REQUEST FOR INFORMATION	DATE: January 06, 2017	NO.: RFI-399
--------------------------------	-------------------------------	---------------------

Project Name: 15051-Webster University Interdisciplinary Science Building	Project No.: 15051
---	--------------------

Subject: Telecom vs Electrical box locations in rm 432 and 434

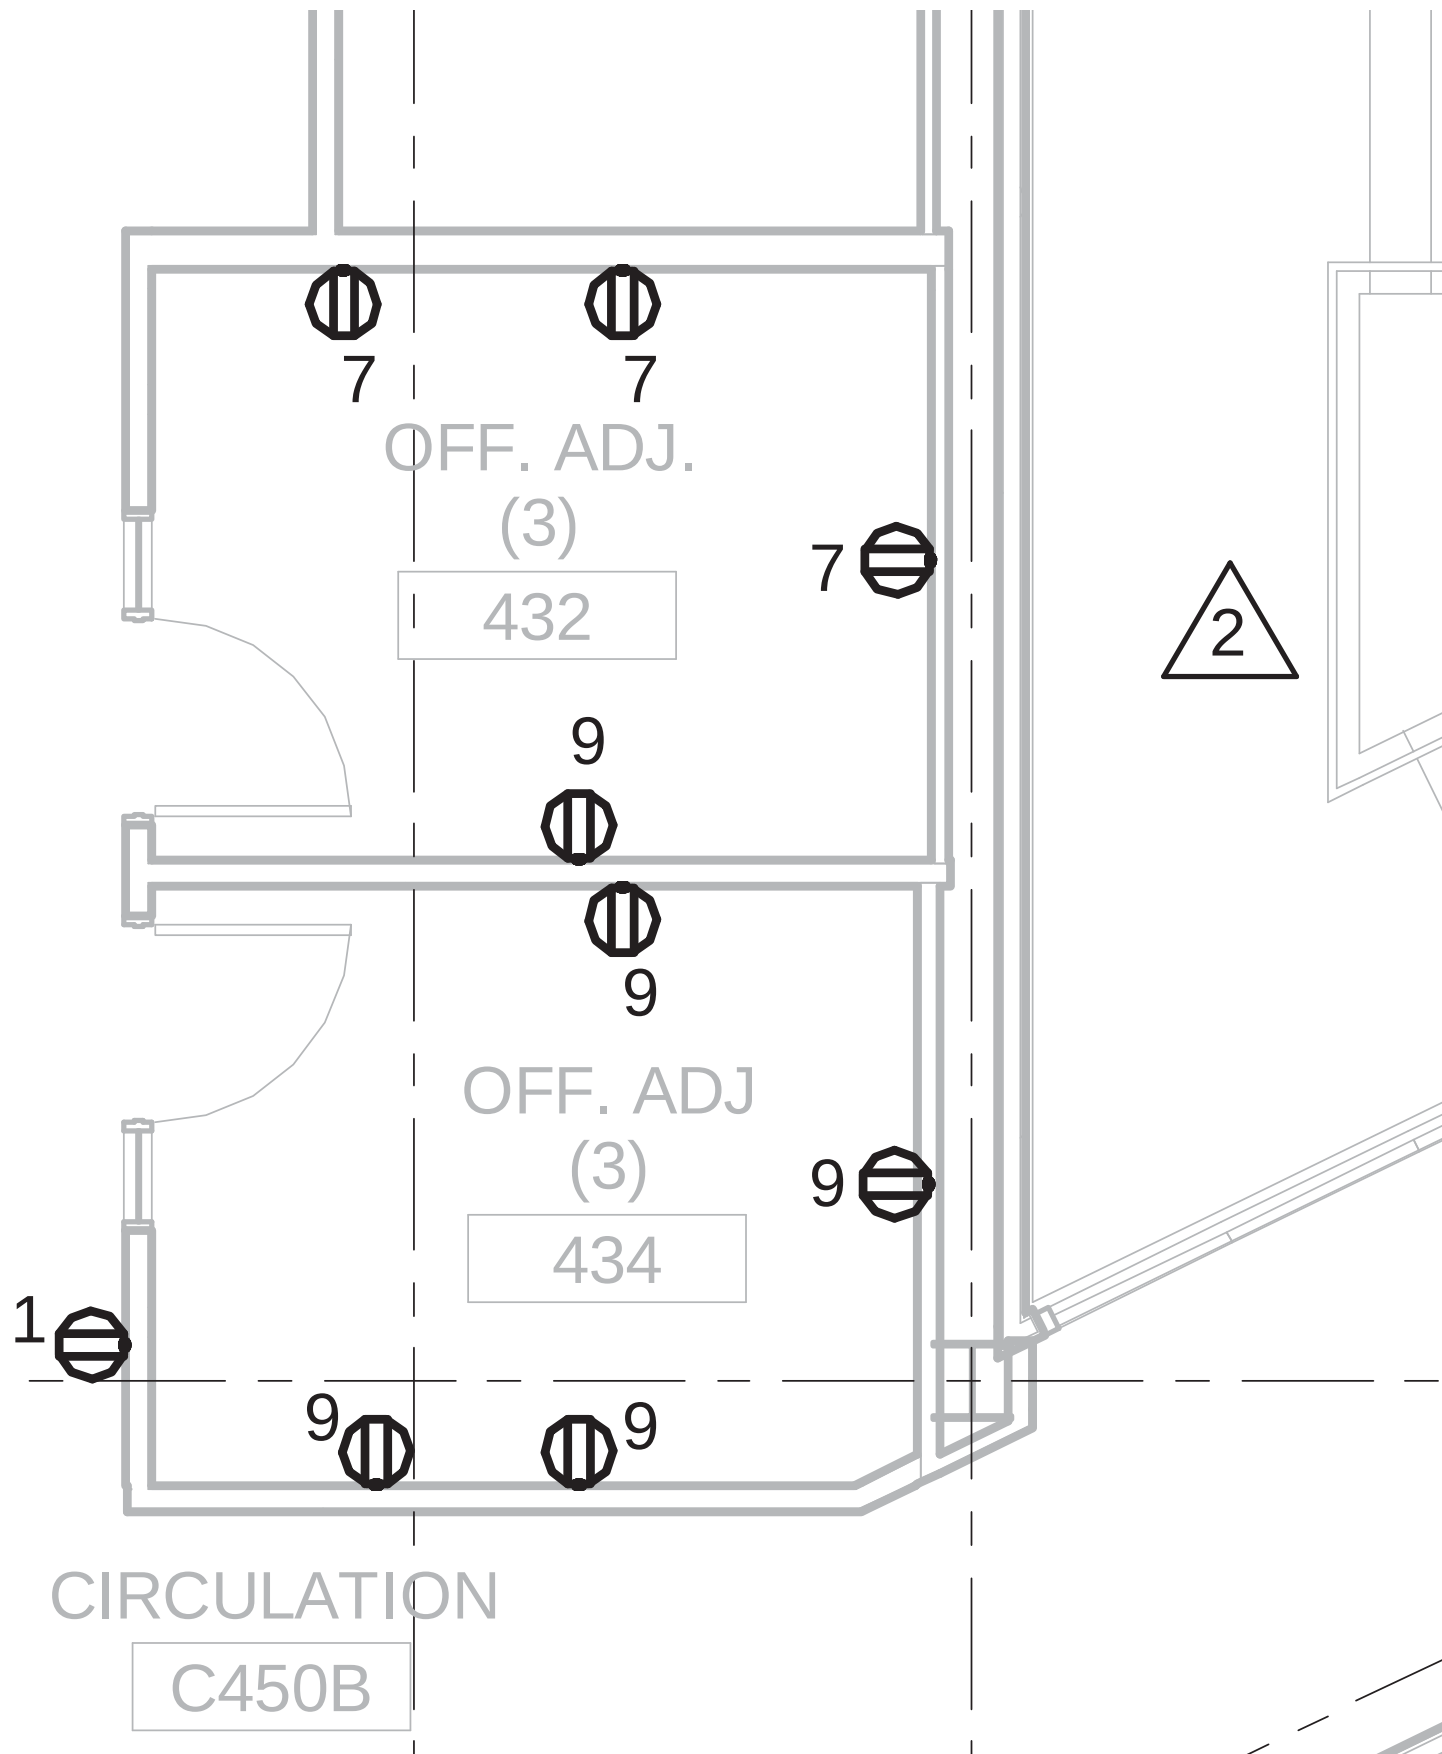
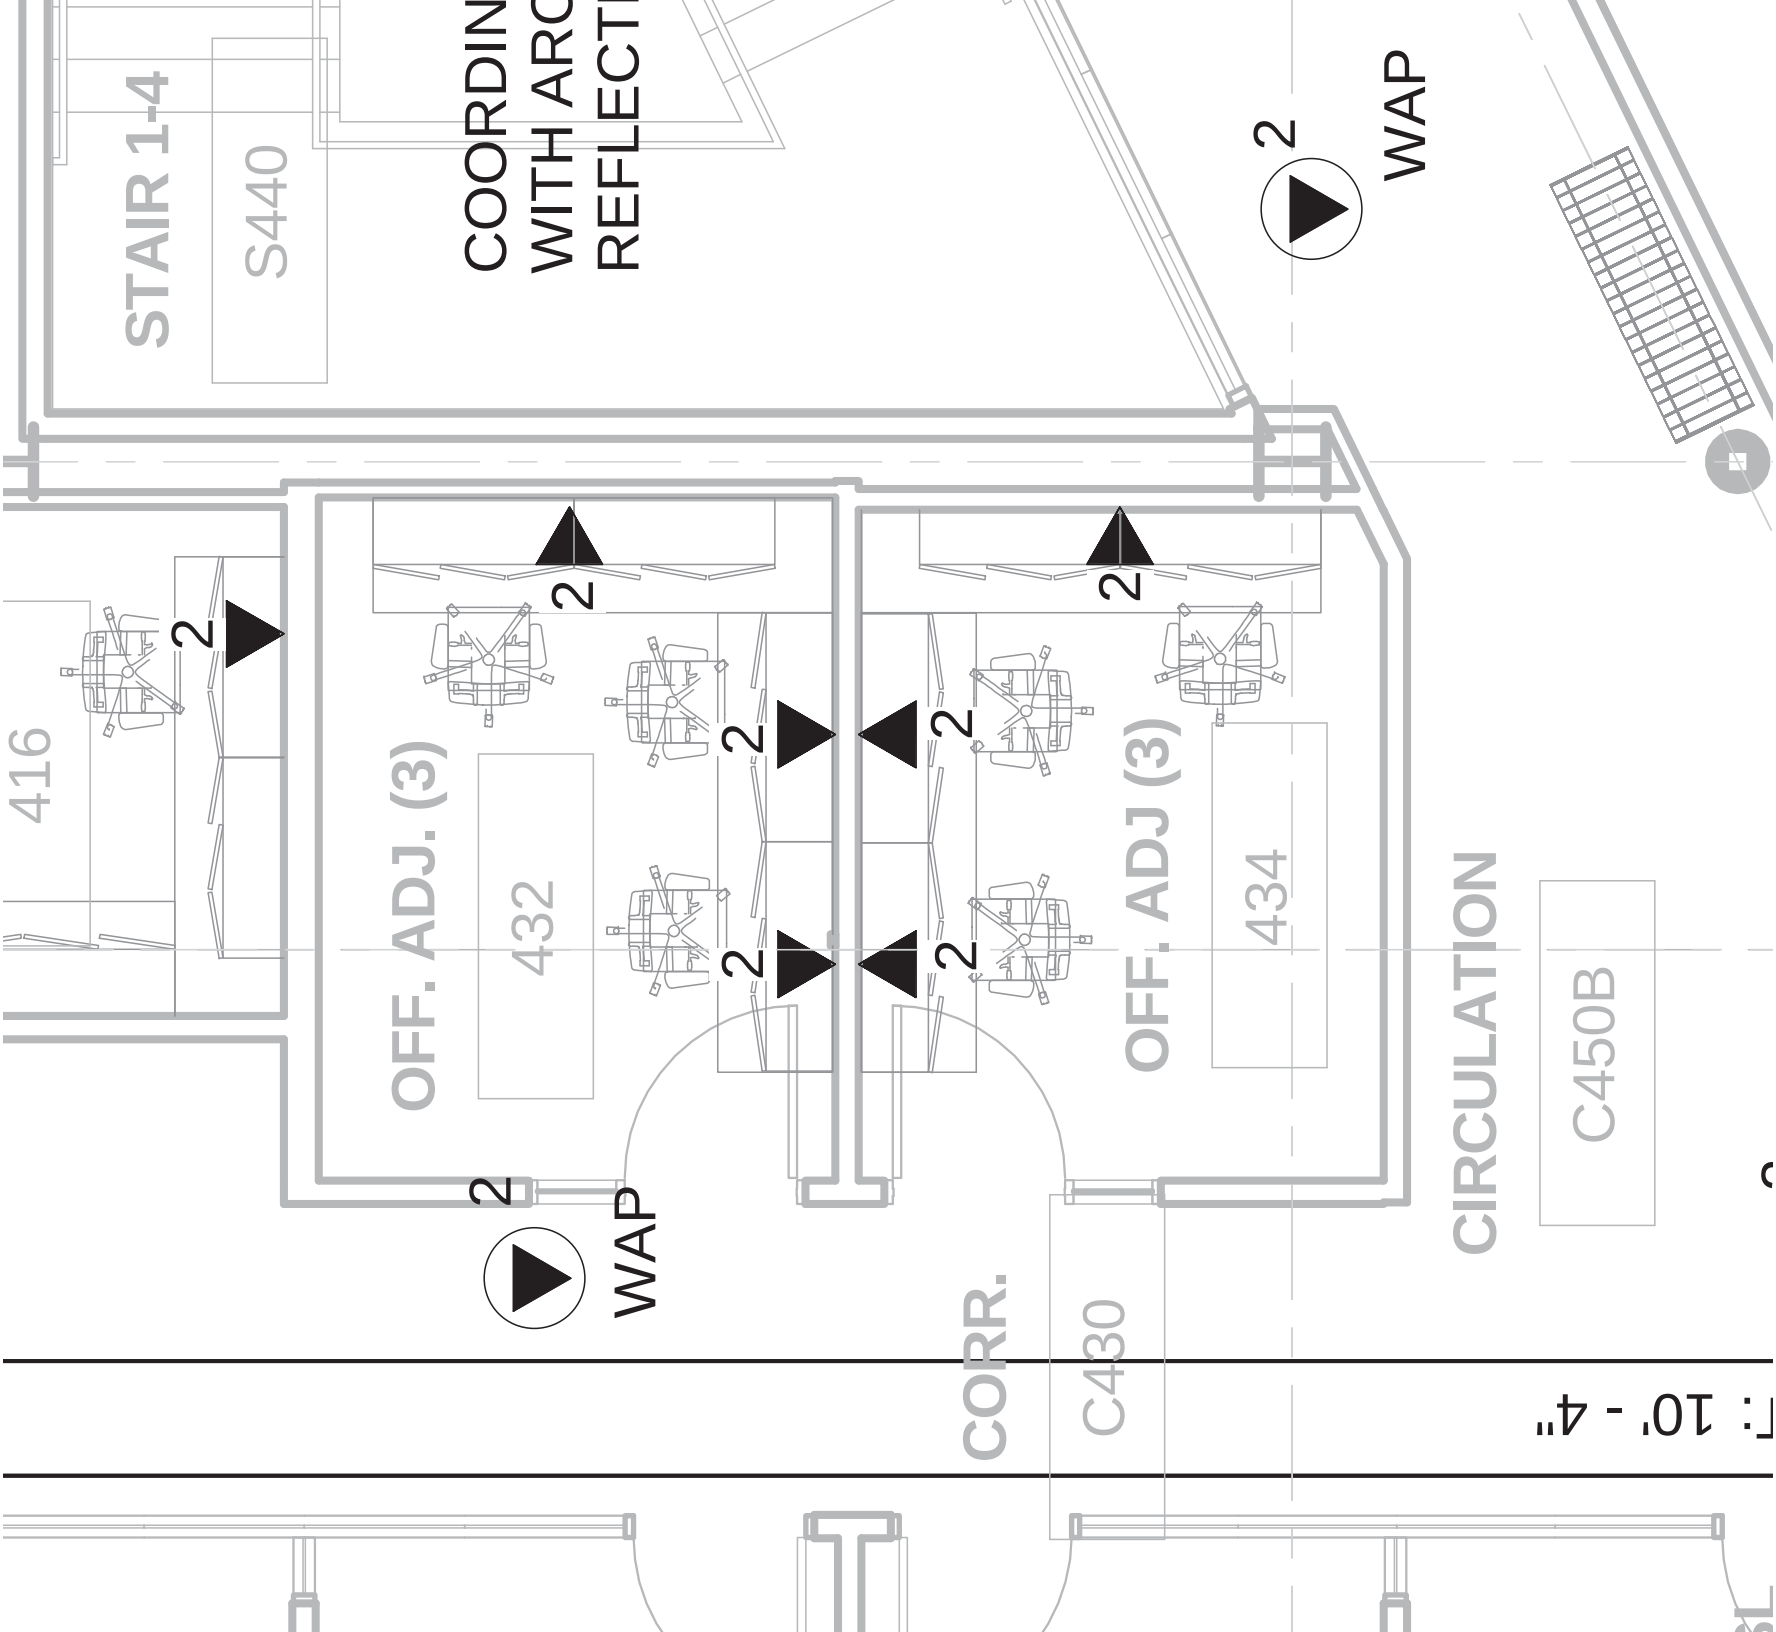
T104.B shows different box locations in rooms 432 and 434 than E0104.B. Please advise as to which are correct.

The furniture layout shown on the Tcom drawings is no longer correct. In Rooms 432 and 434, provide receptacles as shown on Sheet E0104.B and locate the data jacks to match these locations.
